Access Compliance Report

Public Rights-of-Way

(Curb Ramps)

Intersection ID: 53743	Main Street: SMITH_RD	Cross Street: CANTERBURY_CASTLE_DR	Location: SW
ADA ID: 351D4DEF16FA	Ramp Type: BlendTrans1	Initial Pass/Fail: Fail	Overall Compliance: No
		Severity Score: 25

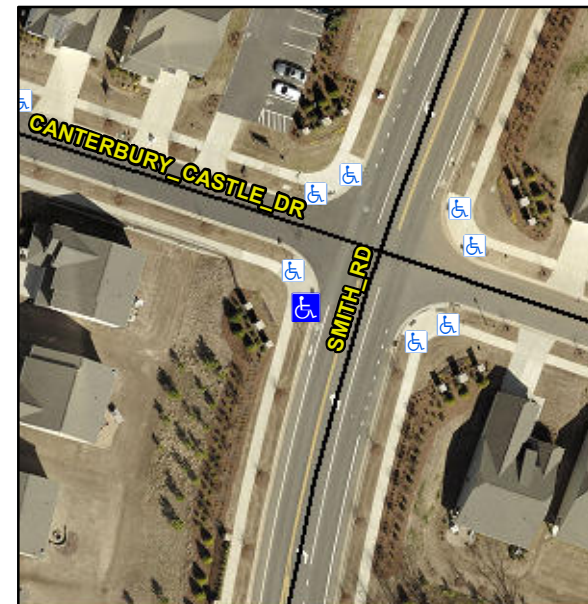
R304.5.3

Compliance	Description	Data	Compliance	Description	Data
N/A	Ramp Length (in)	93.0	Yes	BlendTrans Slope (%)	0.9
Yes	Ramp Width (in)	48.0	No	BlendTrans XSlope (%)	8.6
N/A	Flare Type LT	N/A	N/A	Flare Type RT	N/A
N/A	Flare Slope LT (%)	N/A	N/A	Flare Slope RT (%)	N/A
N/A	Flare Traversable LT?	N/A	N/A	Flare Traversable RT?	N/A
N/A	Landing Length (in)	N/A	N/A	DWS Provided?	N/A
N/A	Landing Width (in)	N/A	N/A	DWS Contrast?	N/A
N/A	Landing Slope (%)	N/A	N/A	DWS Length (in)	N/A
N/A	Landing X Slope (%)	N/A	N/A	DWS Full Width?	N/A
N/A	Landing Curb? (Y/N)	N/A	N/A	DWS Offset (in)	N/A
N/A	Shared Landing?	N/A			
N/A	Gutter Ponding?	N/A	N/A	Gutter Slope (%)	N/A
N/A	Gutter Lip Ht (in)	N/A	N/A	Gutter X Slope (%)	N/A
N/A	Painted X Walk1?	No	N/A	Painted X Walk2?	N/A
	X Walk 1 Direction	To SE		X Walk 2 Direction	N/A
	X Walk 1 Width (in)	N/A		X Walk 2 Width (in)	N/A
	X Walk 1 Slope (%)	0.4		X Walk 2 Slope (%)	N/A
	X Walk 1 X Slope (%)	3.3		X Walk 2 X Slope (%)	N/A

Remove & Replace Curb Ramp With Two New Directional Ramps or Equivalent.
